QUATTRO

New cooling shroud

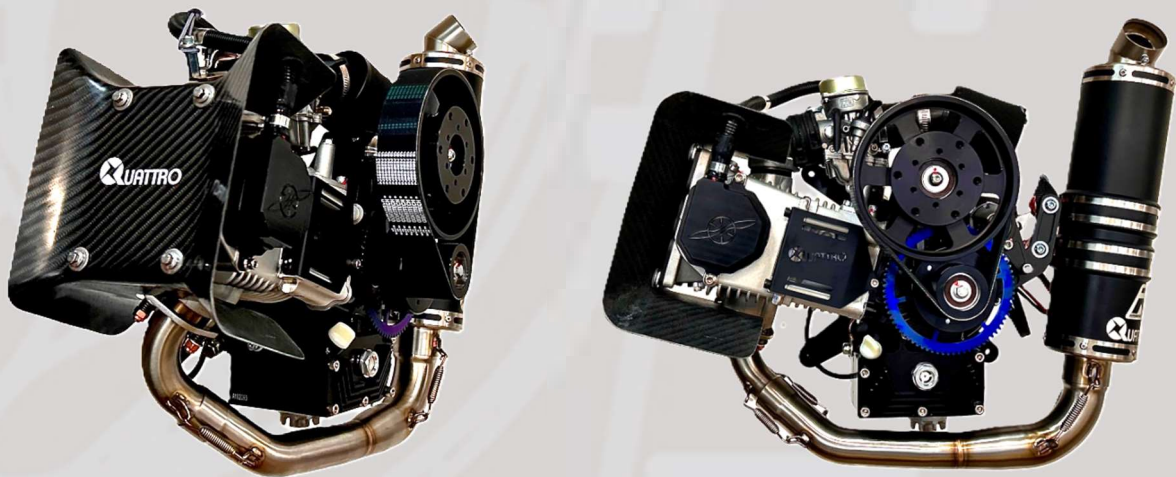
We are pleased to present our EOS Quattro model 2025. It is equipped with a new cooling system. Instead of the oil cooler we will use a carbon fibre cooling shroud for all engines delivered from the beginning of 2025.

This new cooling shroud is more efficient on a paramotor frame than the current oil cooler system. We have been testing this new system for six months. The tests showed that the cylinder head temperature drops by about 30°C and the oil temperature by about 15°C and it saves 0,7 kg of weight.

We can provide an update kit and – if still needed - the oil cooler.
